SECTION 00 91 15

ADDENDUM NUMBER 6

- 1.01 DATE: APRIL 6, 2021**
- 1.02 PROJECT: WELCOME CENTER**
- 1.03 PROJECT NUMBER: DCM NO. 2020604**
- 1.04 OWNER: ALABAMA A&M UNIVERSITY**
- 1.05 ARCHITECT: NOLA | VAN PEURSEM ARCHITECTS, PC**

JOB NUMBER
18994

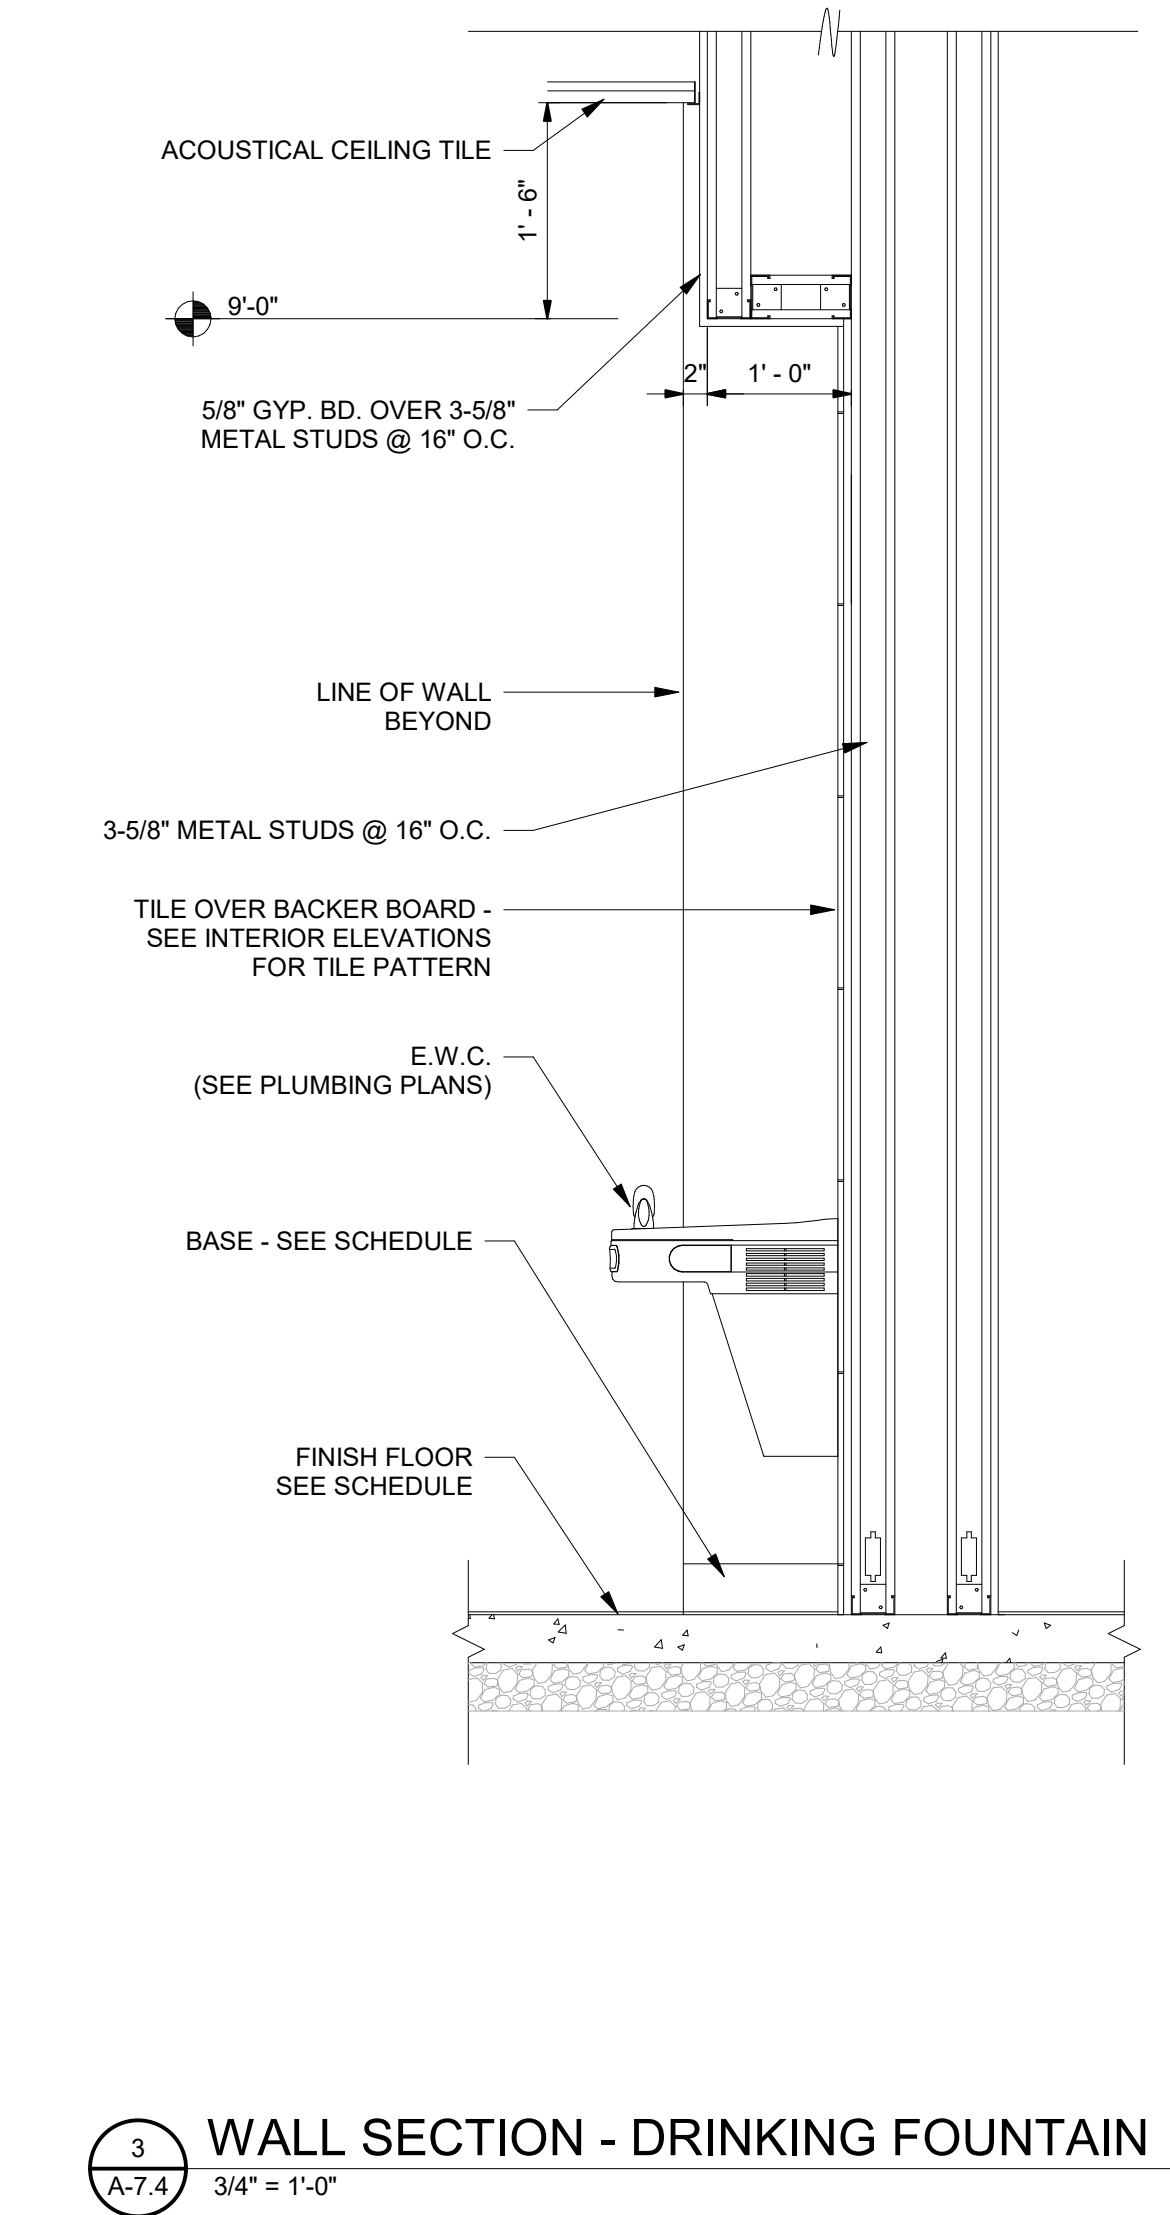
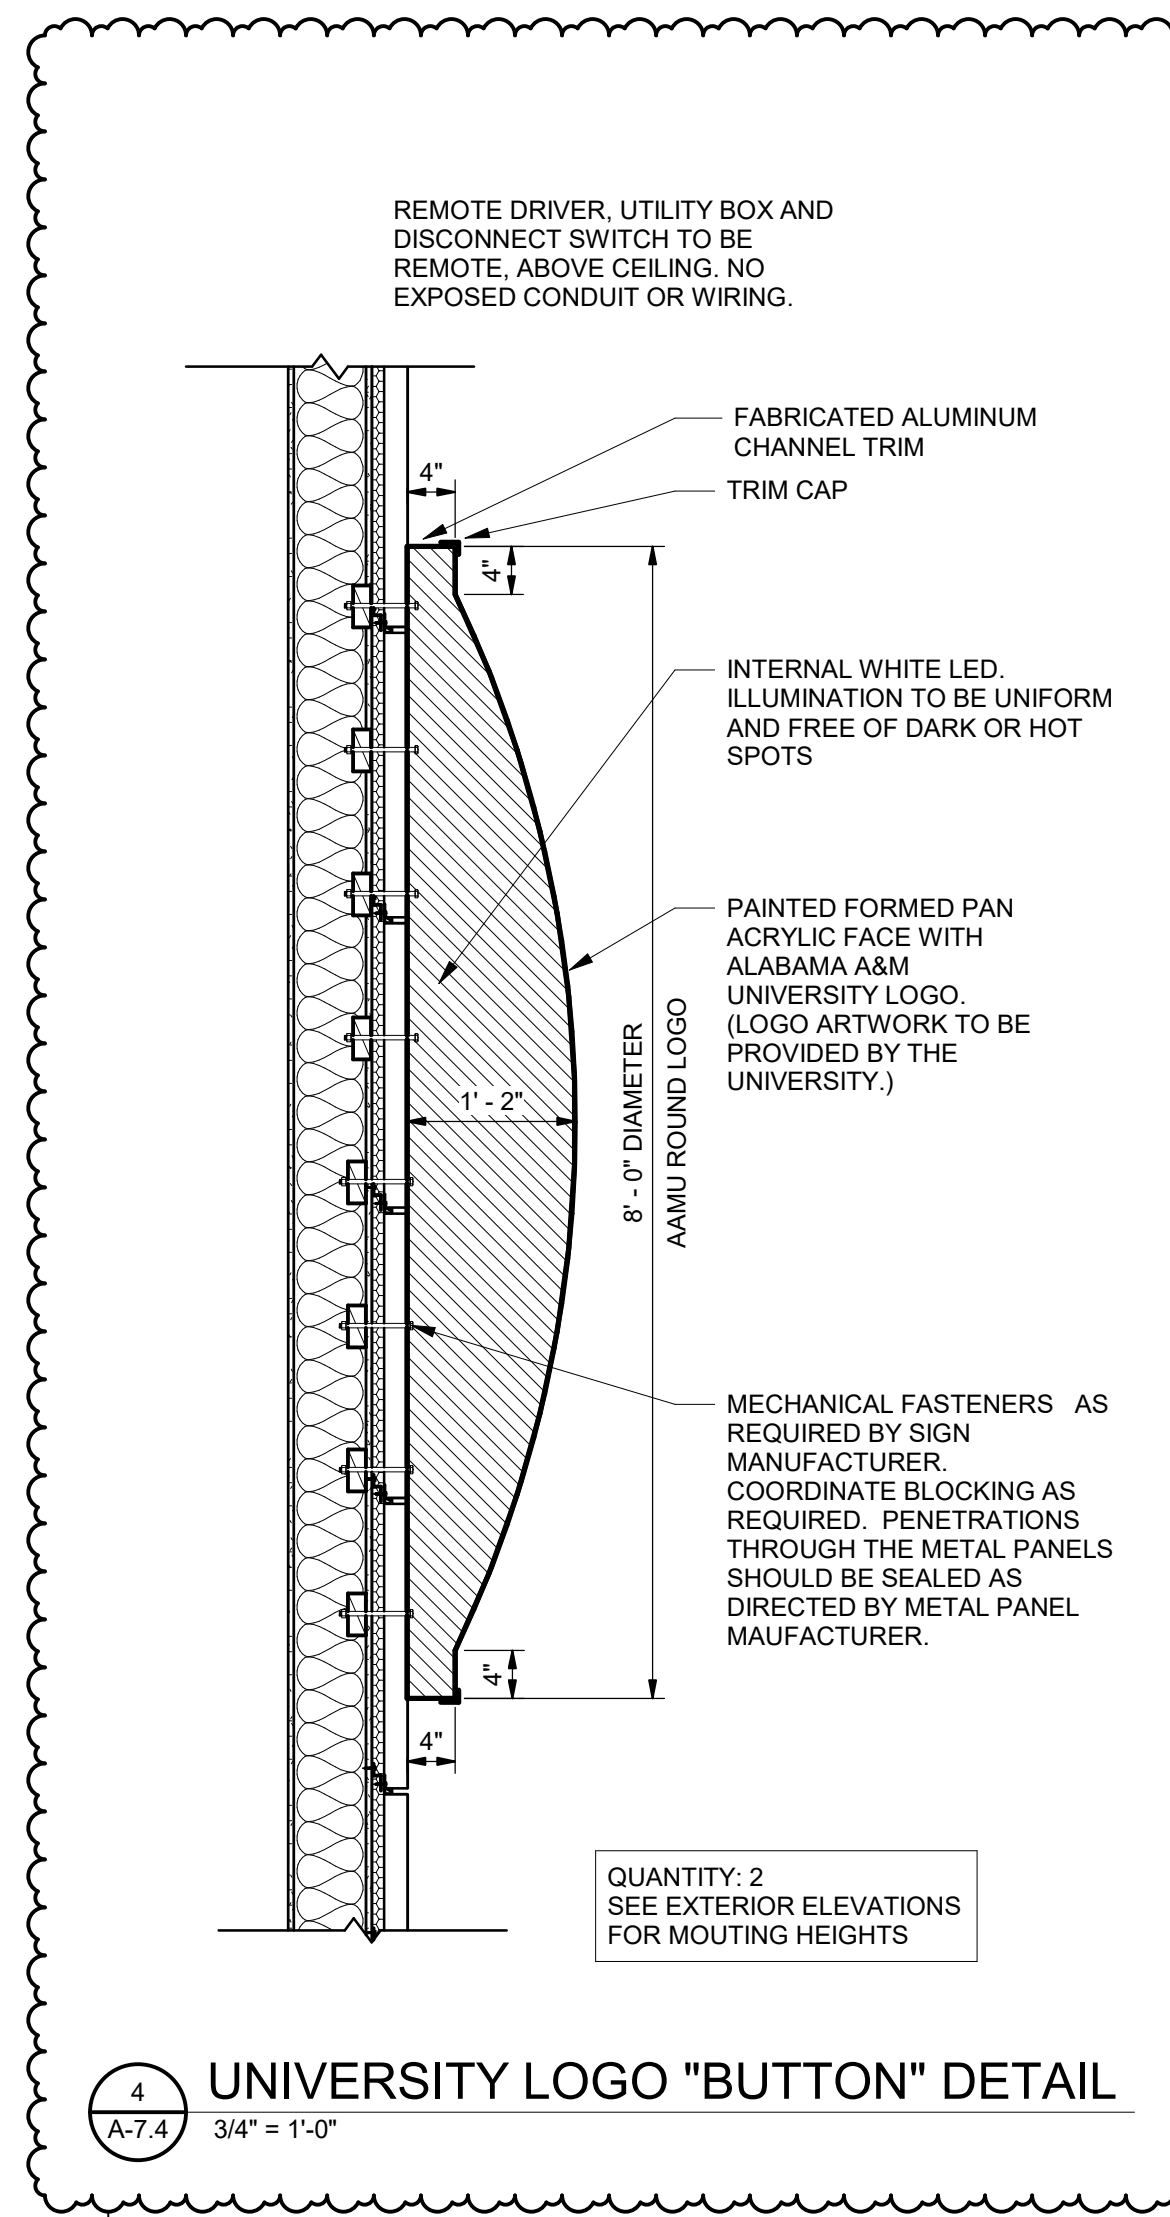
4.15 SHEET A-7.3 – WALL SECTIONS:

- A. Replace this sheet in its entirety. Revisions include the following:
1. Updated notes regarding weather barrier, mortar net, and vapor barrier.
